ADDENDUM #04

INVITATION TO BID #01

**WESTERN CONNECTICUT STATE UNIVERSITY
RENOVATIONS TO
HIGGINS HALL & HIGGINS ANNEX**

STATE PROJECT NO: BI-RD-290-CMR

TYPICAL ROOF SCREEN WALL SECTION
NOT TO SCALE

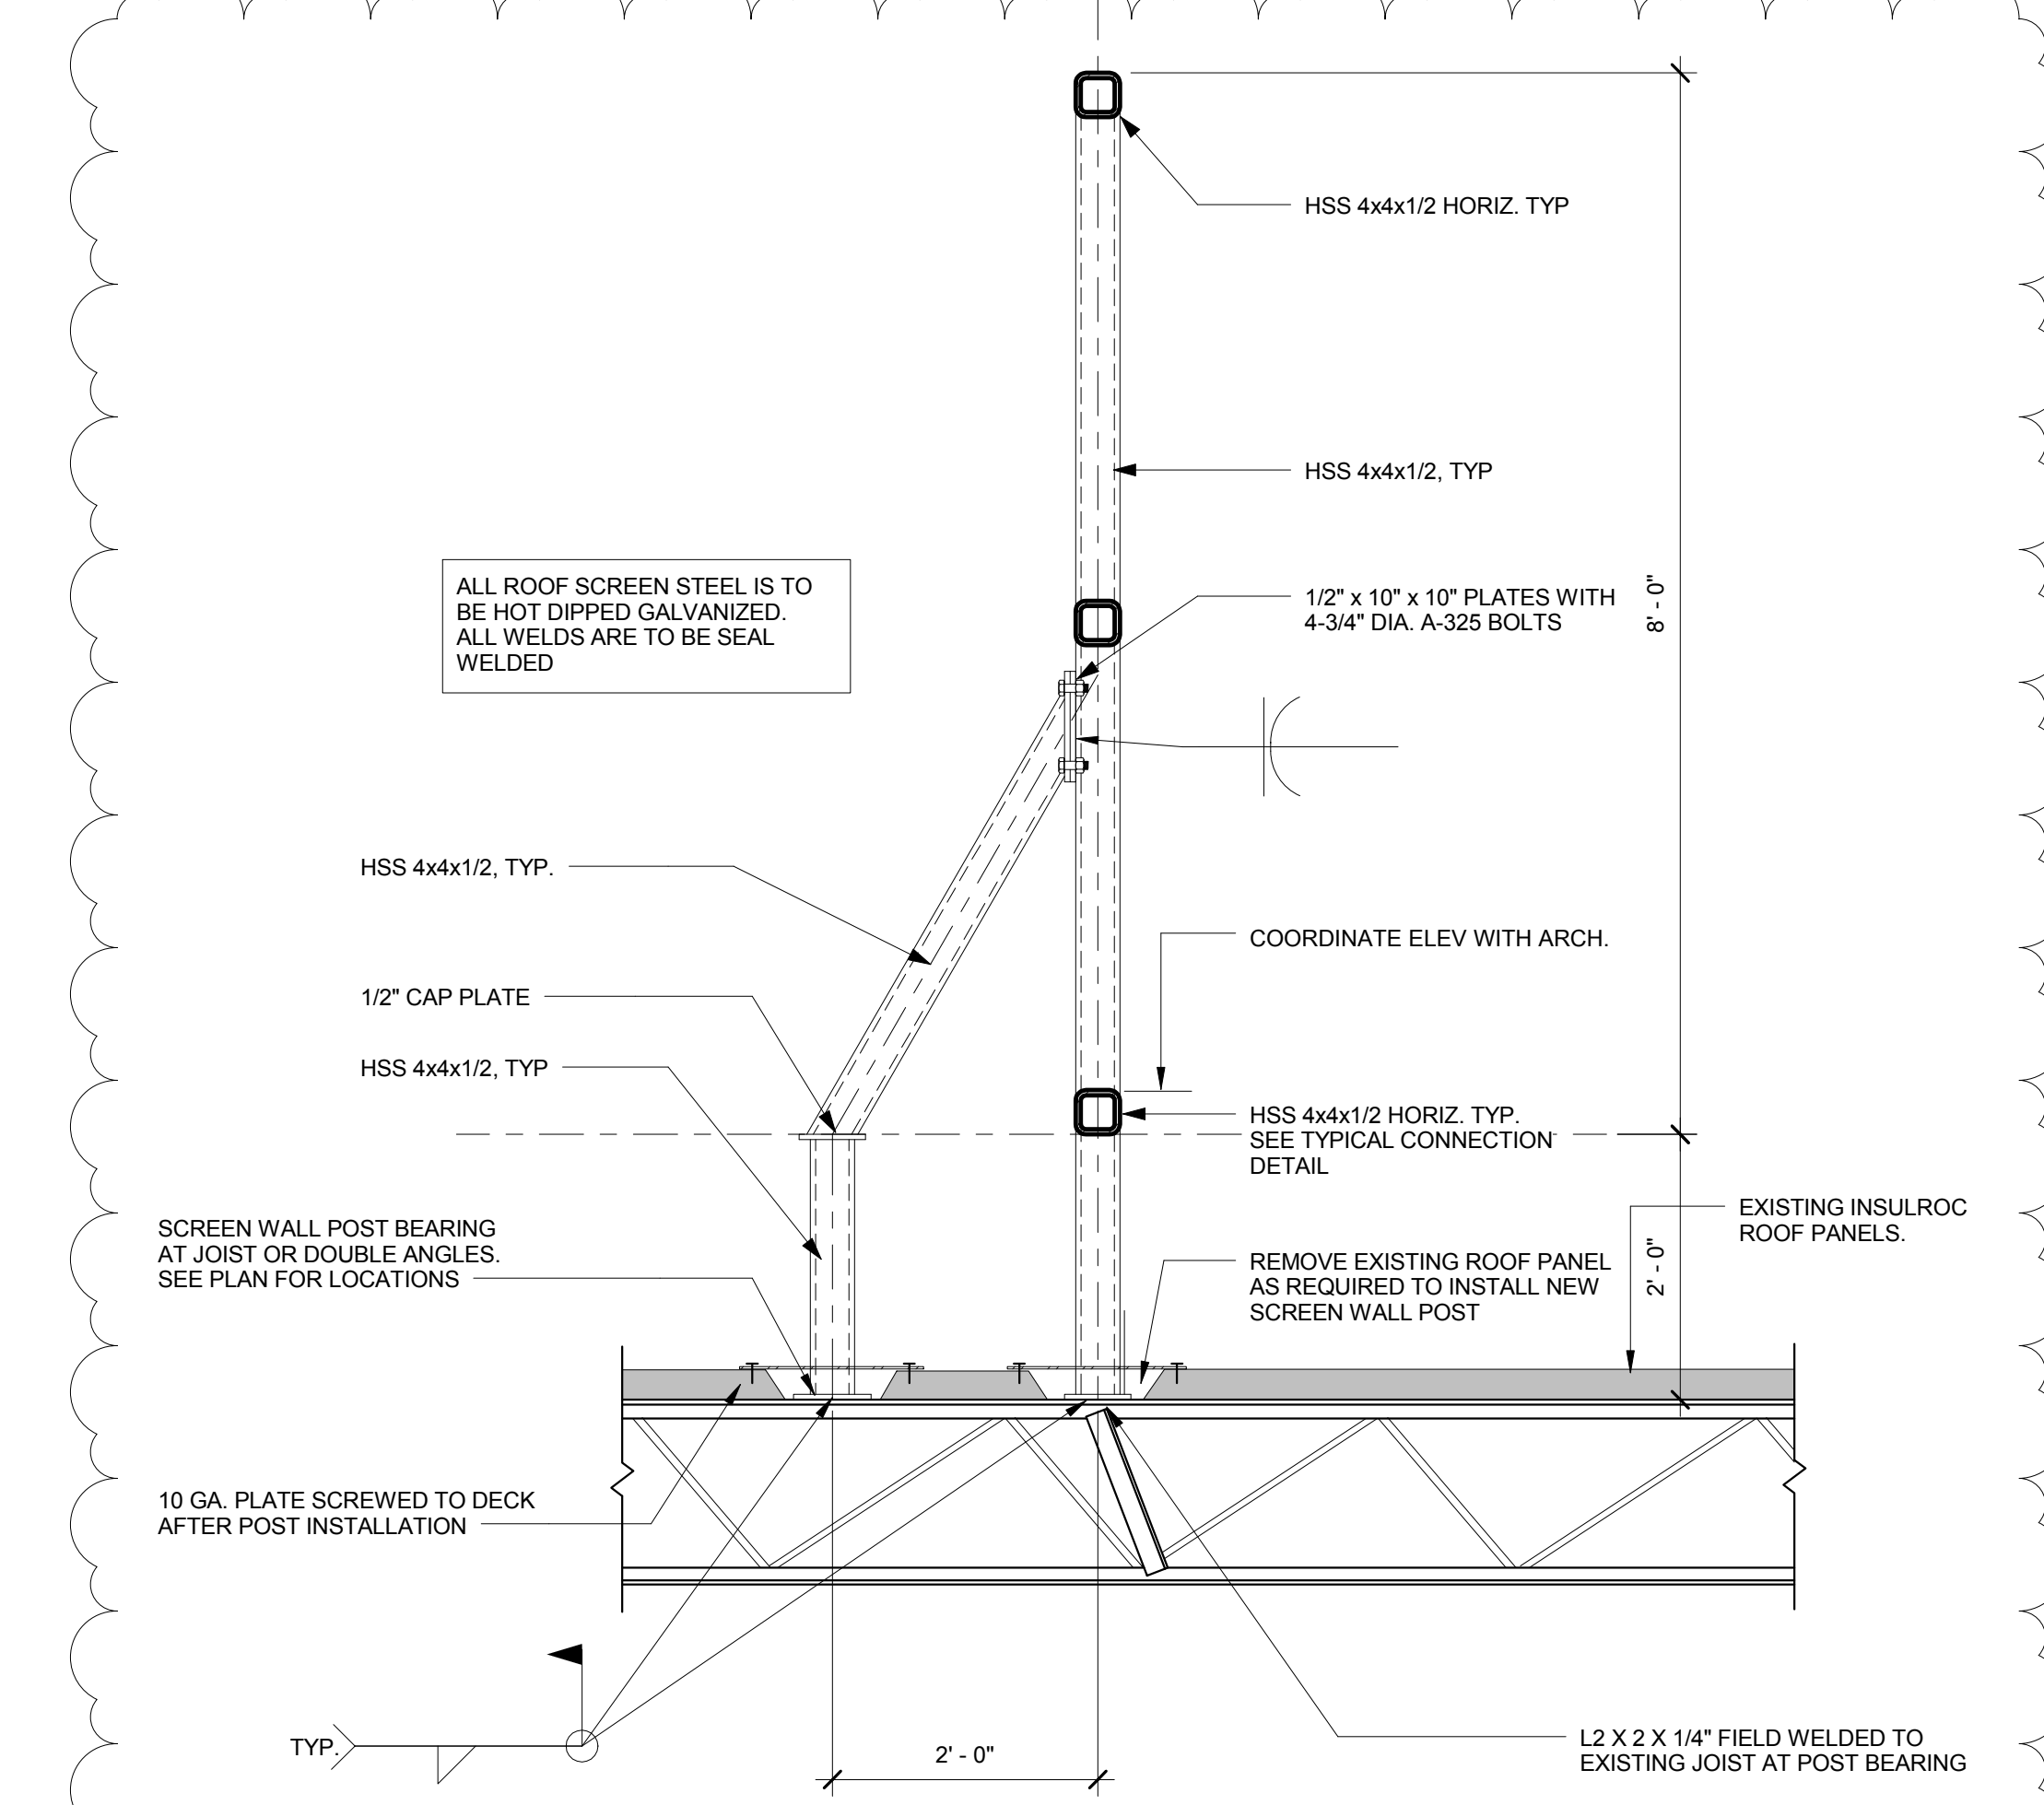
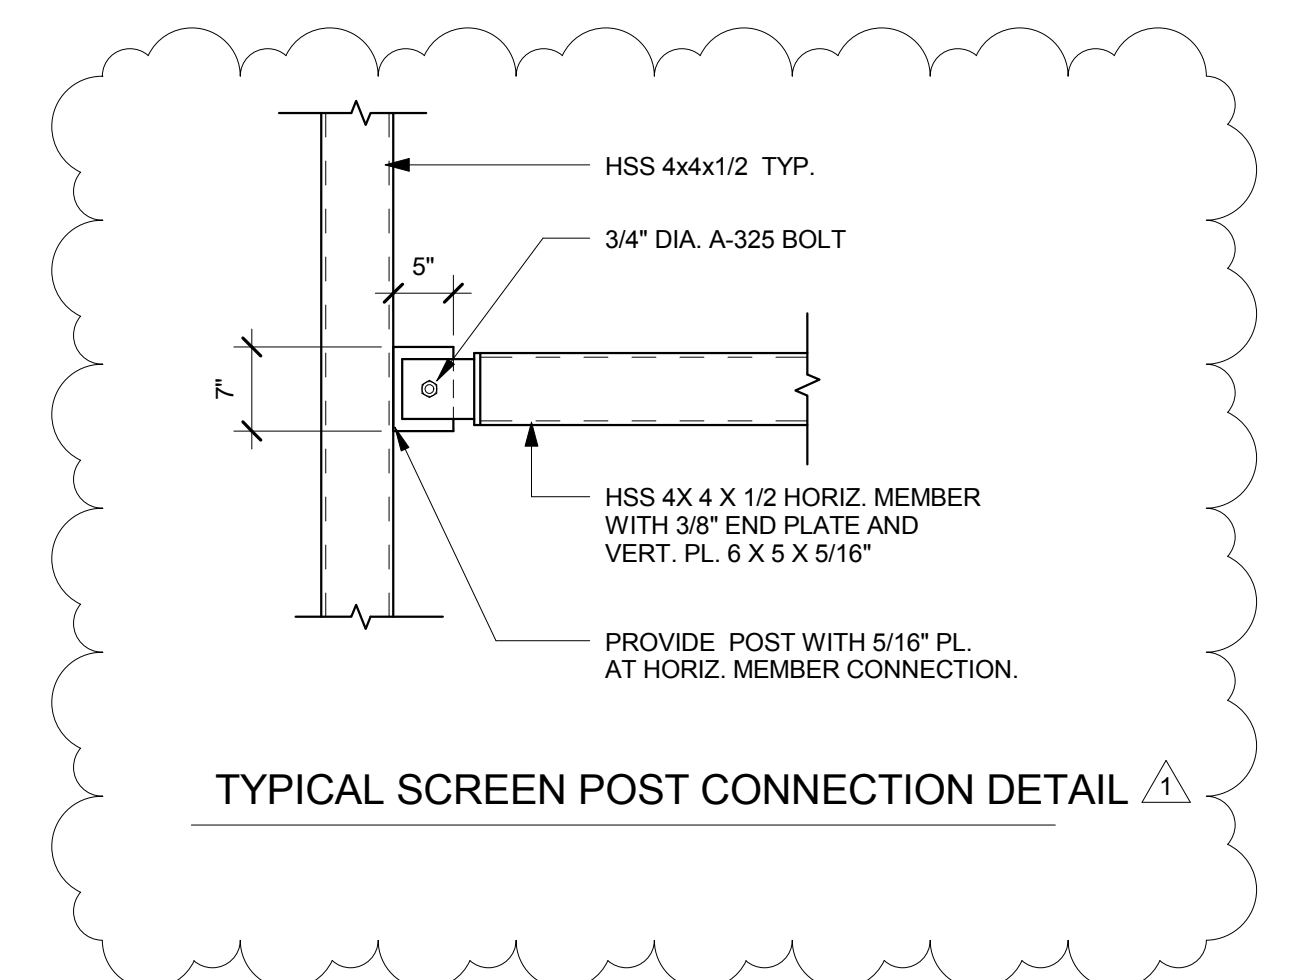
- RFI G** **Question** – Regarding the Roof Screen Tube Erection Details, in order to save time and for constructability, we would like to be able to field bolt all horizontal tubes to the vertical members. (Detail on S4.1) We would shop weld plates at each end of the horizontal members and at the proper location on the vertical members to accomplish this. Is this acceptable?

Answer – *This is acceptable. See attached revised S4.1.*
- RFI H** **Question** – Please confirm spec section "074213 Formed Metal Wall Panels" in the table of contents is the same as spec section 081113 Formed Metal Wall Panels in Volume 2 of the specification.

5. S1.31:
 - Replace drawing with revised S1.31.
6. S3.1:
 - Replace drawing with revised S3.1.
7. S4.1
 - Replace drawing with revised S4.1

ROOF PATCH INFILL DETAIL AREA B

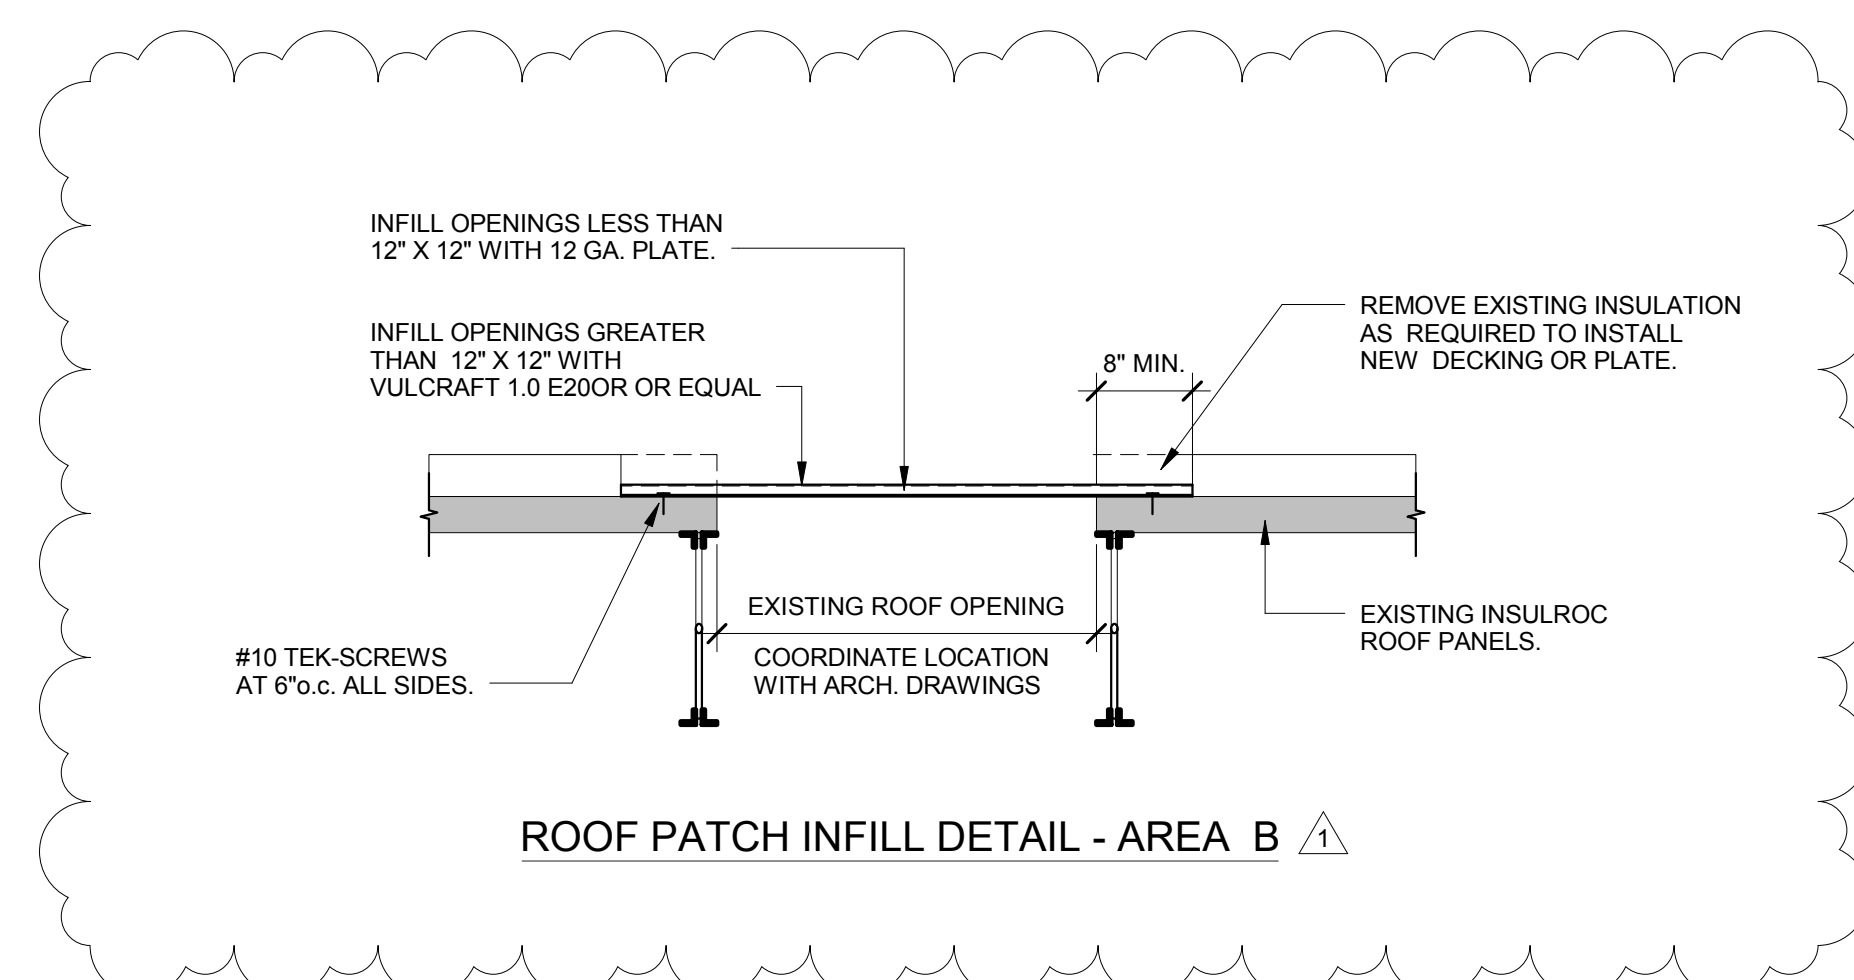
RFI BB Question – Reference D1.31A note 14, provide details for capping this condition and similar.

Answer – *Yes. The roof shall be patch to match existing insulation and roofing. The roofing shall be filed verified. Also see details for patching shown on revised Architectural and Structural Drawings included with this Scope.*
